STAFF REPORT
COMMUNITY DEVELOPMENT DEPARTMENT

HEARING DATE: 10/25/2022
TO: Mayor & City Council
FROM: Sonya Allen, Associate Planner
208-884-5533
SUBJECT: FP-2022-0029
Prescott Ridge No. 2
LOCATION: East side of N. McDermott Rd., south of
SH 20-26 in the NE ¼, the SW ¼ and
the NW ¼ of Section 28, Township 4
North., Range 1 West.

Final plat consisting of 71 building lots and 8 common lots on 14.44 acres of land in the R-8 zoning district for the second phase of Prescott Ridge Subdivision.

B. Final Plat (date: 8/1/2022)

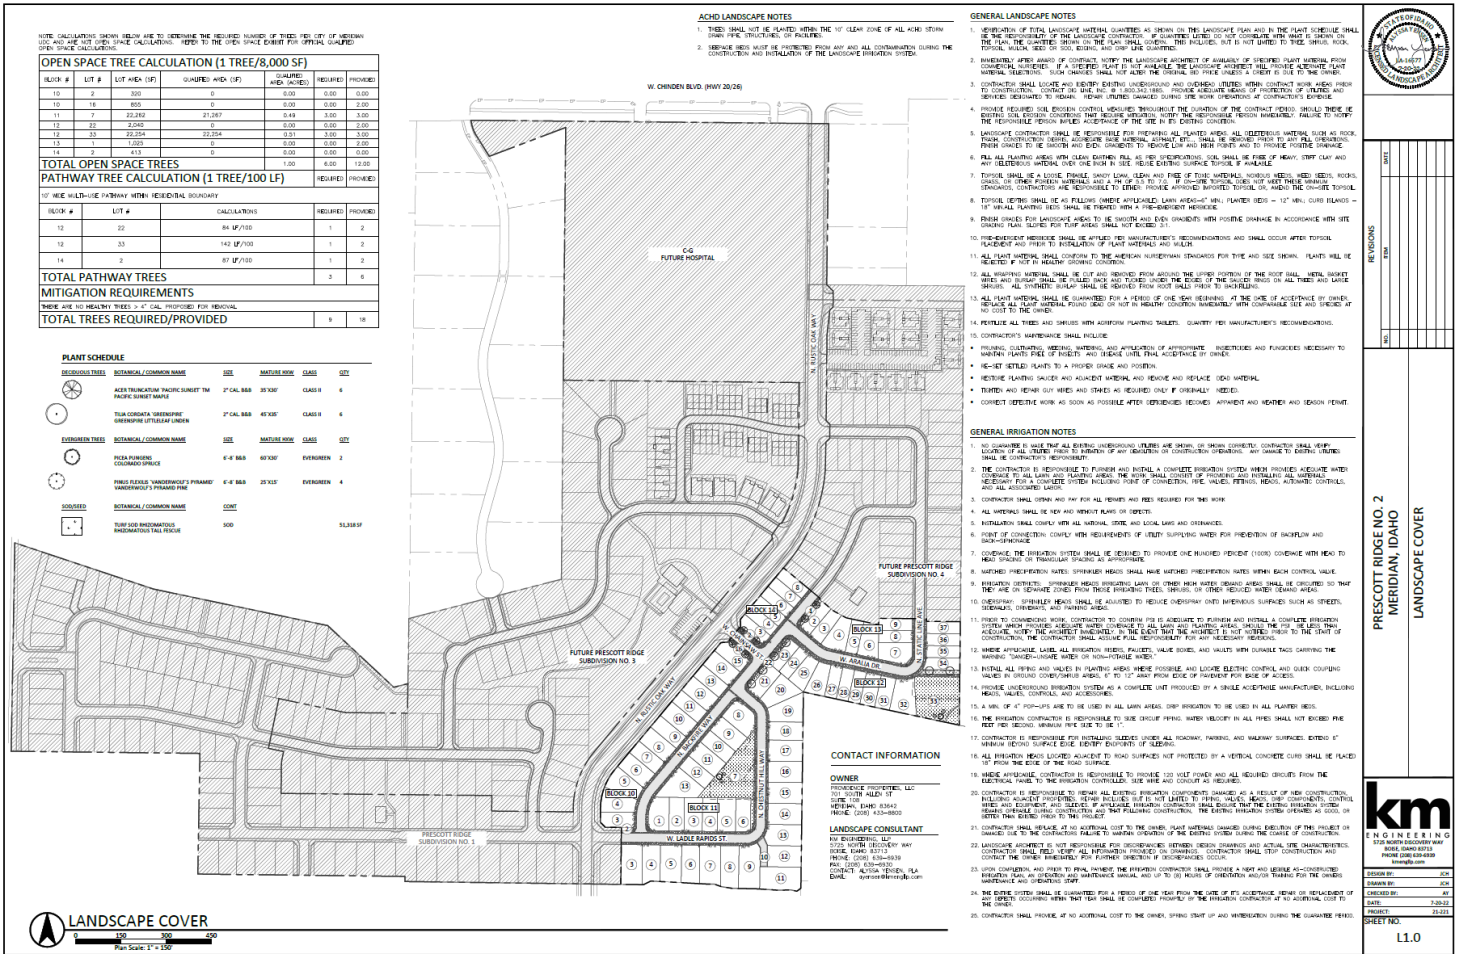
- a. Under References, R3 – include the Book and Page numbers of Prescott Ridge Subdivision No. 1.
 - b. Note #15: Include the recorded instrument number for the ACHD permanent easement.

- c. Depict zero (0) internal lot lines on the lots in Block 12 where attached units are proposed that will span over the property line.

C. Landscape Plan (date: 7/20/2022), Fencing Plan & Amenity Details

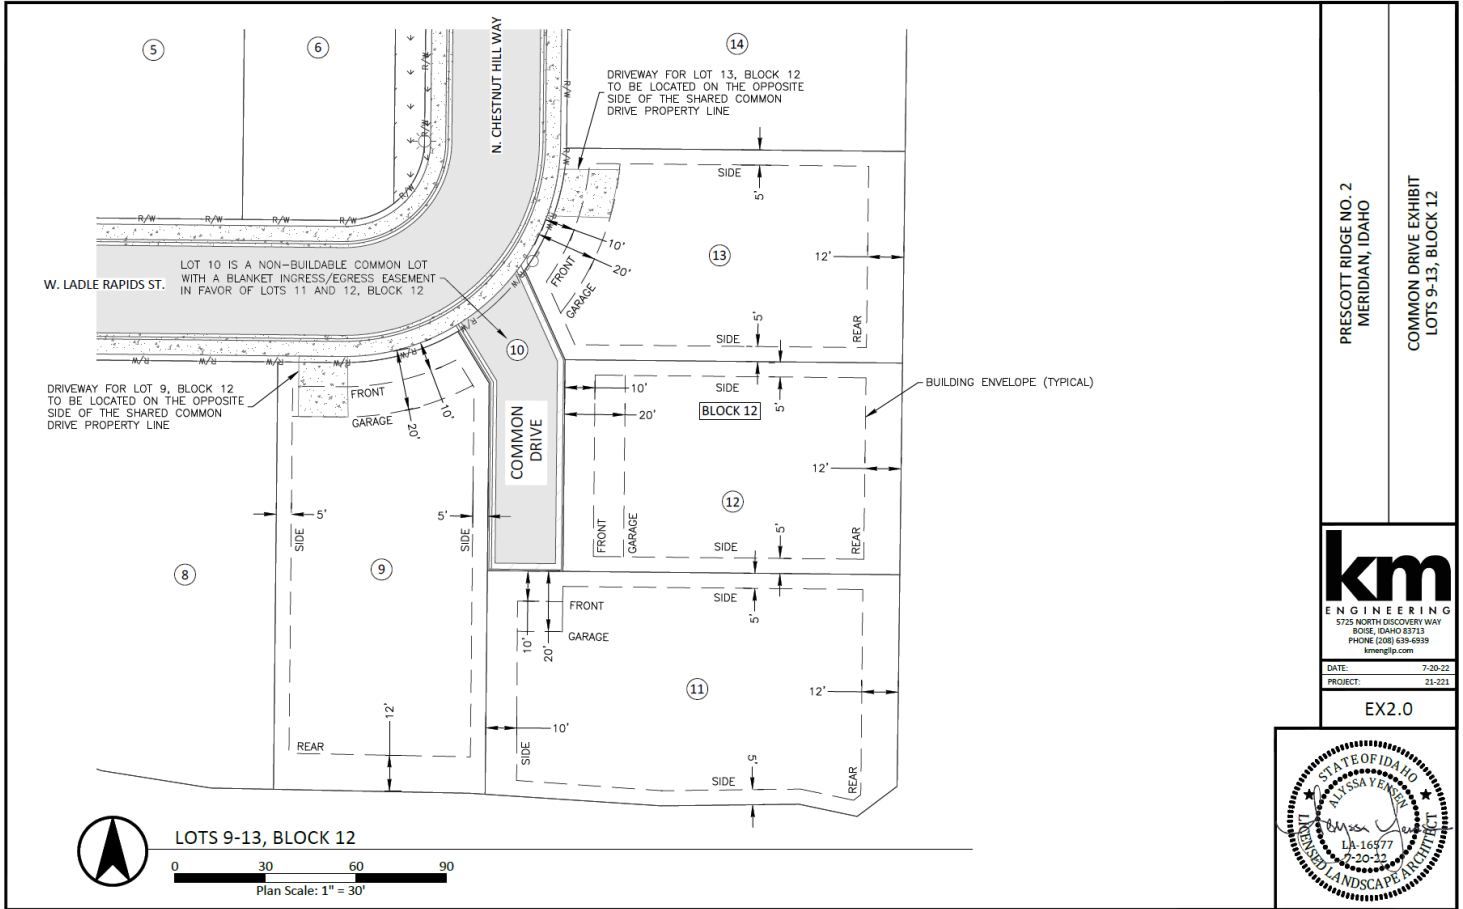
5. The landscape plan shown in Section V.C, dated 9/23/21, shall be revised as follows:
 - a. The 6-foot tall solid vinyl fence with lattice top shall have a maximum of 4-feet of solid material with 2-feet of lattice; depict accordingly on the detail on the fencing exhibit (Sheet L3.0).
 - b. Landscaping shall be depicted along *all* pathways in accord with the standards listed in UDC [11-3B-12C](#); include a *mix* of trees and shrubs along with lawn and/or other vegetative groundcover.
 - c. If fencing is proposed along the east side of Lot 9, Block 12, depict a minimum 5' wide landscape buffer along the west side of Lot 10, Block 12 planted with shrubs, lawn or other vegetative groundcover as set forth in UDC [11-6C-3D.5](#). Depict fencing on the plan if proposed.
